**From:** [Private General](#)  
**To:** [Planning Info](#)  
**Subject:** question for the developer  
**Date:** Friday, October 9, 2020 2:23:05 AM

When comparing the site plans(2017 vs 2020) for 88/89 Foundry Place it is difficult to ascertain **how high the physical building will be on the Hill St side including whatever amount of grade** may be necessary to even it off with the lower Foundry Place side. Some neighbors are wondering if it would be possible to ask Market Square Architects to show that on their plans. Could this information be provided BEFORE the Planning Board meeting?

**From:** [Robin Husslage](#)  
**To:** [Tracy A. Gora](#)  
**Subject:** Planning Board Meeting 10/15/2020-89 Foundry Place  
**Date:** Wednesday, October 14, 2020 9:23:14 PM  
**Attachments:** [image.png](#)  
[image.png](#)  
[image.png](#)  
[image.png](#)  
[Rezoning Requests to Planning Department.pdf](#)

I am against extending the request of Foundry Place, LLC, Owner, for property located at 89 Foundry Place for amended Site Plan Review Approval and a third 1-year extension of the Site Plan Review approval that was originally granted on November 16, 2017 and most recently granted a second

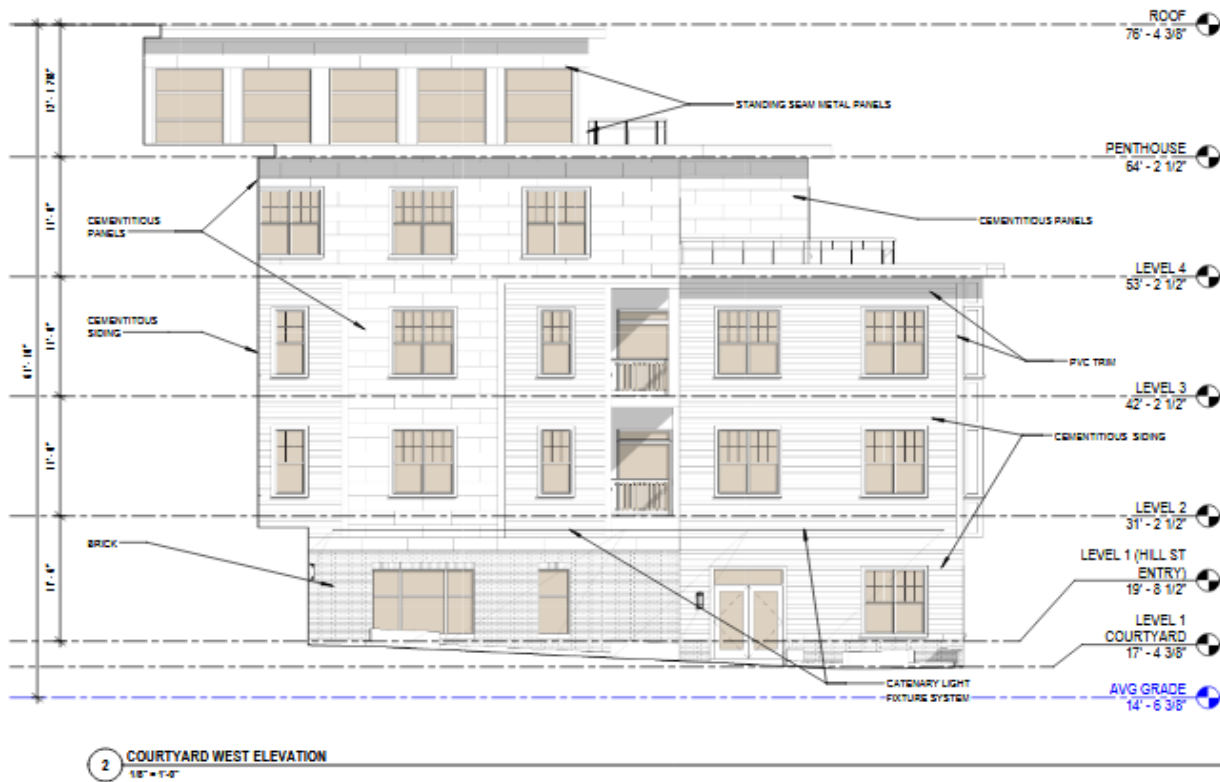
There is a BIG difference in this amendment in the height of 88/89 Foundry Place on Hill Street! The 2017 height on Hill St was shown (see step down below) as a step down height with the first height of 53' 2 1/2" which included the grade of 14' 6 3/8". The NEW proposal does NOT show a step up on the Hill St side and presently shows the height as 69' 3 1/2" including a 15' 6 1/2" grade. THIS IS A 16' 1" INCREASE IN HEIGHT ON HILL STREET, which is about 1 and half stories more. Please NOTE the Foundry Place side in 2017 showed a height of 76' 4 3/8" with a 14' 6 3/8" grade and it now shows a 69' 3 1/2" height which is ONLY a 7' 7/8" decrease than the original 2017 building. The Foundry Place height reduction is not even a whole story!

I have asked the Planning Department to ask the developer to show the actual height including grade on Hill St. It is NOT likely a building will have the same amount of grade under it when it sits on a hill *UNLESS the entire hill is removed and then grade added to increase the area needed for underground parking*. I would ask the Planning Board either keep the original plans OR ask the developer to include similar steps and a lower height (including the proposed grade) in the 2020 amendments on the Hill Street side.

The first floor shows a lot of changes including adding 12 residential units by removing the 16 parking spaces and an office space. Originally there were 50 on-site parking spaces in 2017 for their 43 units. The new proposal shows 34 spaces on-site for their 55 units. The new amendment shows 35 spaces will be in the Foundry Garage, which can be done to off-set the required 68 spaces. *This will leave NO spaces for future developments of Lots 4 and 5. It is the change being made on the first floor of removing the 16 parking spaces and adding more residential units which could have negative consequences for parking in the neighborhood.* **If allowed**, the 16 parking spaces could be retained from the 2017 original approval and the Office Space could be changed into 4 to 6 more of the desired increase in units. If changes are NOT able to be put forward to the proposed amendments please keep the original 2017 plan for the 16 parking spaces and the penthouse. This may have a much lesser impact on the neighborhood.

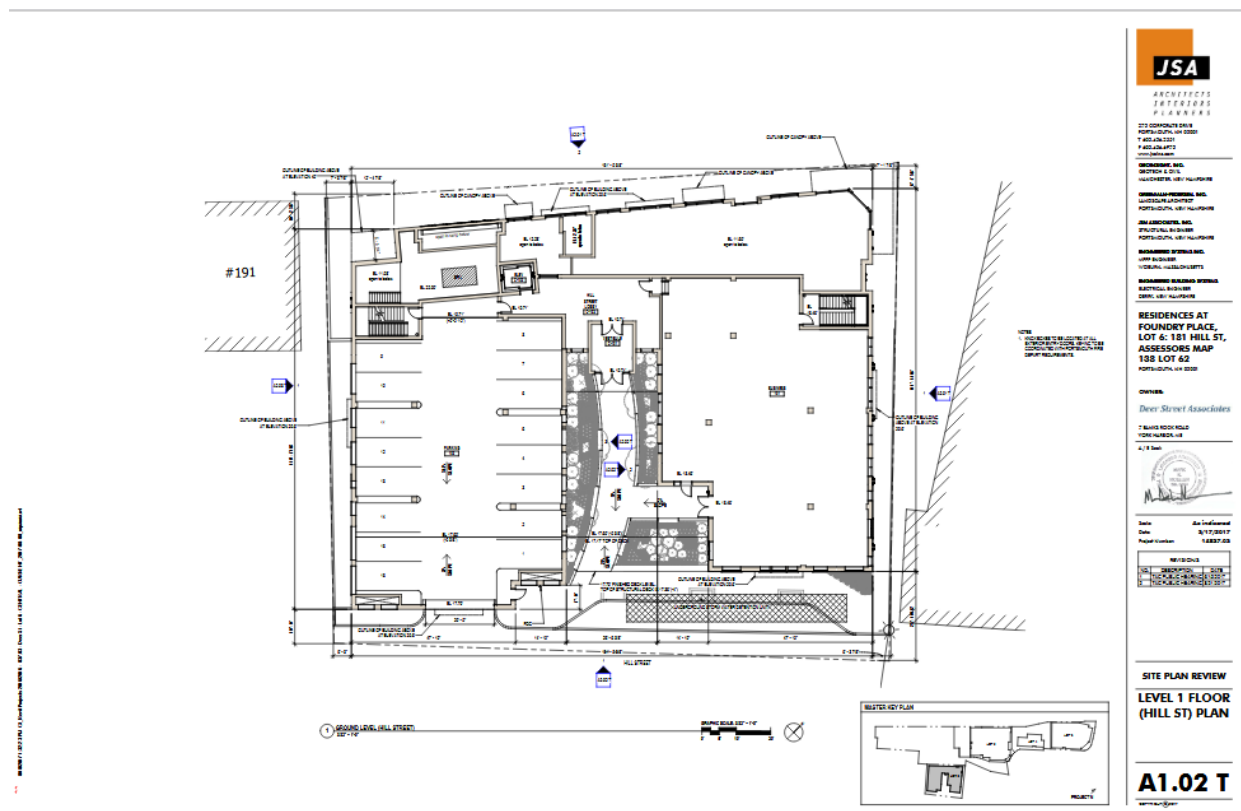
Differences between	2017	2020	Change
Maximum Building Footprint	16364 SF	16196 SF	168 Ft smaller
Building Height	61'10"	53' 9"	8' 1" shorter (does not include grade)
Building Stories	4+ Penthouse	4+deck	-penthouse + deck
Minimum Ground Story Hgt	18'11"	20' 2 3/4"	2' 8 1/4" higher

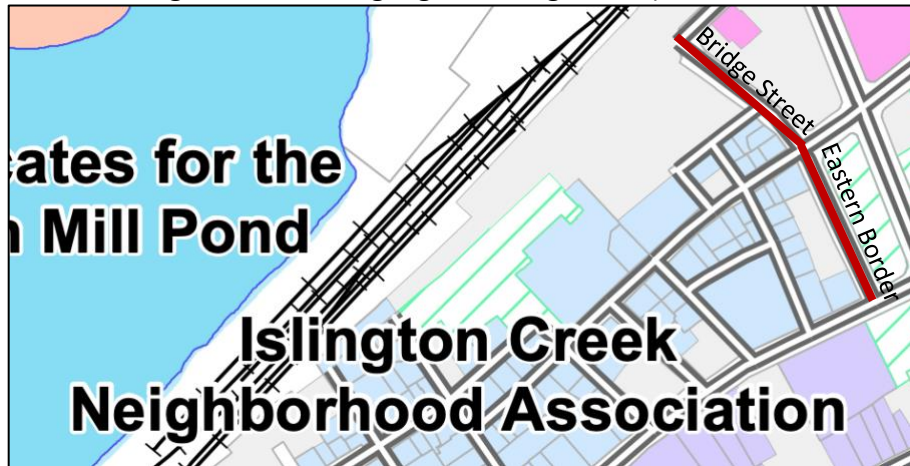
(2) **The Proposed Design Changes of Squaring off the building rather than stepping down the height of the building on the hill street side as originally proposed increases the impact to the surrounding neighborhood especially Hill Street.** It is also critical to have updated renderings of the redesigned building and surrounding area from different perspectives, especially from Hill Street side so its impact and relative size, scale, and massing can be accurately judged from the surrounding neighborhood similar to what was provided for the original plans:
